## PIC16(L)F15325/45 Family Silicon Errata and Data Sheet Clarification

The PIC16(L)F15325/45 family devices that you have received conform functionally to the current Device Data Sheet (DS40001865D), except for the anomalies described in this document.

#### 2.1 Figure 37-5: Clock Timing

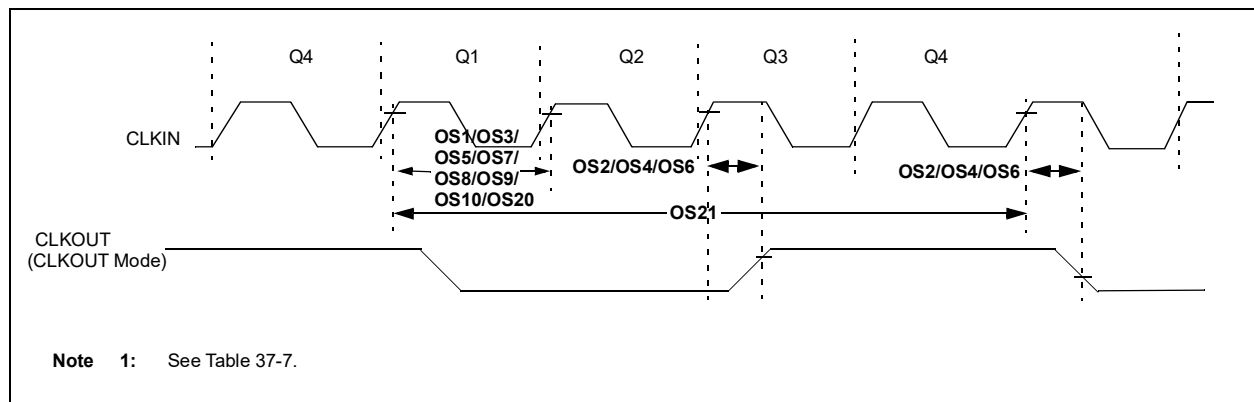
Figure 37-5 incorrectly shows the location of parameters OS1, OS2, OS3, OS4, OS5, OS6, OS7, OS8, OS9, OS10, OS20 and OS21. The correct location for the above-mentioned parameters is depicted in the following figure.

#### 2.2 Figure 37-9: Brown-Out Reset Timing and Characteristics

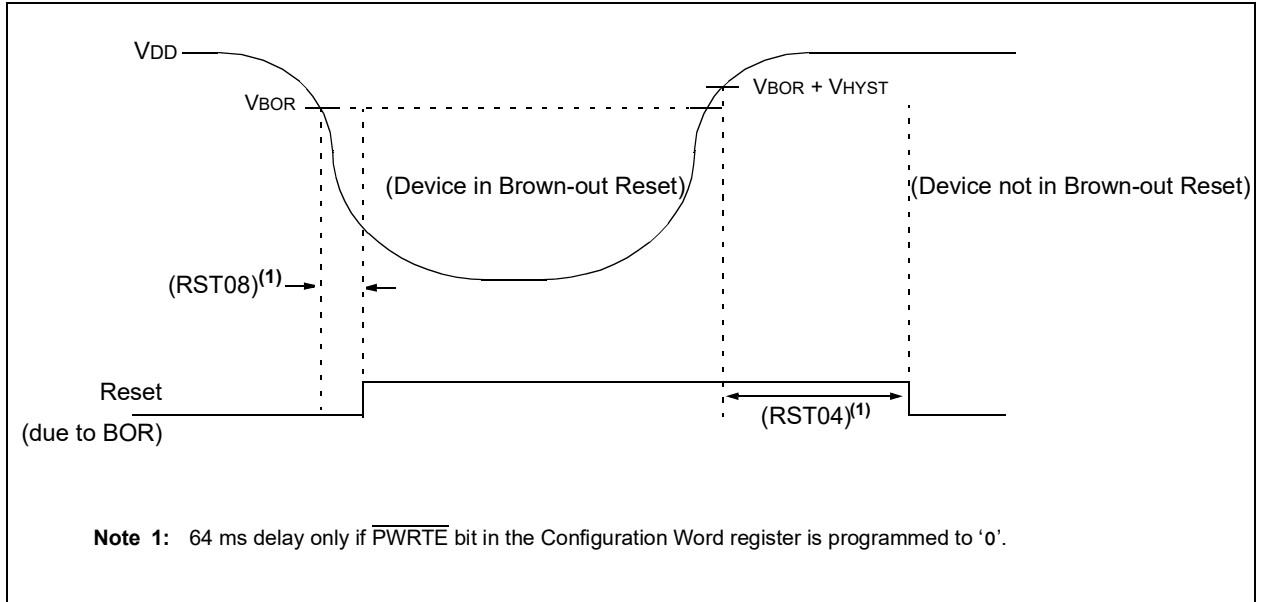
Note 1 in Figure 37-9 is incorrect. The correct note along with the figure is depicted below.
